21/2509/MRES | Reserved matters application for layout, appearance and landscaping for the main local route through the town centre (Tillhouse Road), the link road to the B3174 (Court Royal) and Crannaford Lane and drainage works on land adjacent to Tillhouse Road.

Exeter Cycling Campaign would like to **object** to the current layout plan for Tillhouse Road in Cranbrook. This important road passing through Cranbrook's future town centre has been designed around the needs of private motor car users at the expense of pedestrians and people who cycle. This despite the Design and Access statement proclaiming that:

Figure 2: Junctions in the area covered by this application.

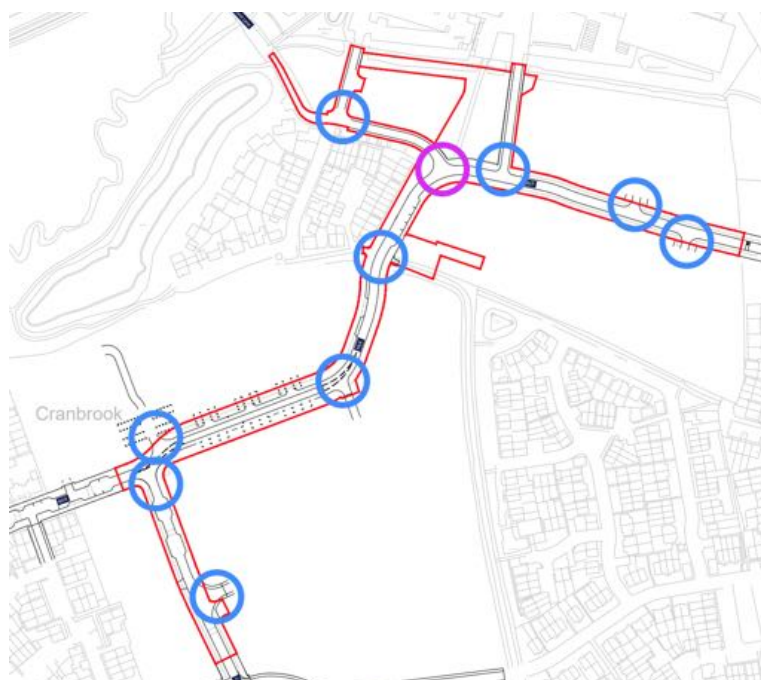
There are 10 junctions covered by this application area, marked in Figure 2. With the exception of a proposed zebra crossing at the junction of Crannaford Lane and Tillhouse Road (circled in pink), at each junction cars have apparent priority over pedestrians or cyclists using the shared pavements who wish to cross. Updates to the highway code are pivoting towards providing pedestrians and cyclists with priority when crossing junctions, but infrastructure needs to make this priority clear.

Furthermore some of the junctions have excessively large kerb radii, allowing cars to make turns at higher speed than is necessary in a low speed town centre environment. This is notable at the Crannaford Way junction where a crossing is planned, and at the entrance to the Morrison's car park. Pedestrians and cyclists crossing these junctions must contend with higher speed car movements that should be mitigated by making the corners tighter, and thus forcing drivers to manoeuvre more slowly.

If the junction crossings in general are not reprioritised in favour of pedestrians and cyclists, then as a minimum the zebra crossing over Crannaford Lane needs to be made into a parallel crossing (one that legally allows for bicycles to cross as well). Furthermore, it needs to connect to a shared use path on the eastern side of Crannaford Lane. In the current design the crossing is set back from the junction in such a way that the pavement on the eastern side is too narrow to be shared use (visible in the plan view in Figure 4). This despite the wide shared use path along Tillhouse Road either side of this point. Without widening the pavement on the eastern side of Crannaford Lane this will be a very significant pinch point, especially given its use by lots of children to reach the school.
